<b>Title - Sujet</b> BIO Ellis Lab Roof	
<b>Solicitation No. - N° de l'invitation</b> EB144-210747/A	<b>Amendment No. - N° modif.</b> 003
<b>Client Reference No. - N° de référence du client</b> EB144-21-0747	<b>Date</b> 2020-09-29
<b>GETS Reference No. - N° de référence de SEAG</b> PW-SPWA-405-6038	
<b>File No. - N° de dossier</b> PWA-0-84038 (405)	<b>CCC No./N° CCC - FMS No./N° VME</b>
<b>Solicitation Closes - L'invitation prend fin</b> <b>at - à 02:00 PM</b> <b>on - le 2020-09-30</b>	<b>Time Zone</b> <b>Fuseau horaire</b> Atlantic Daylight Saving Time ADT
<b>F.O.B. - F.A.B.</b> <b>Plant-Usine:</b> <input type="checkbox"/> <b>Destination:</b> <input checked="" type="checkbox"/> <b>Other-Autre:</b> <input type="checkbox"/>	
<b>Address Enquiries to: - Adresser toutes questions à:</b> Kendell (PWA), Byron	<b>Buyer Id - Id de l'acheteur</b> pwa405
<b>Telephone No. - N° de téléphone</b> (902) 497-5345 ( )	<b>FAX No. - N° de FAX</b> (902) 496-5016

**Solicitation Amendment 003 is being raised to answer bidder questions, as follows:**

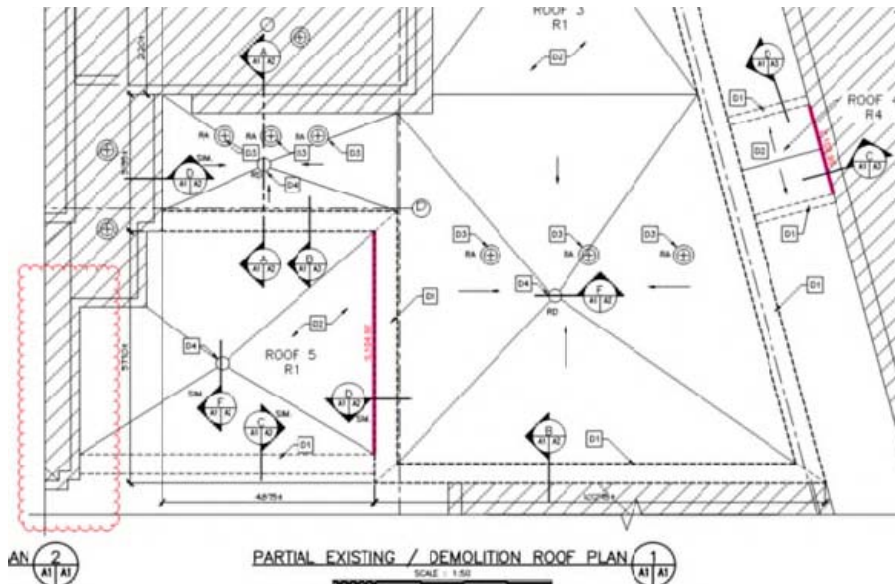
**Question 1:** Upon reviewing the demolition plans and also from my site visit I remarked something. I noticed that on one area of the roof, there is brick located on two opposite walls. However; only one wall is calling for the brick to be removed. Is there no need for the other wall to have the masonry removed? Please see below.

**Answer 1:** Detail D would apply to this section of wall as well.
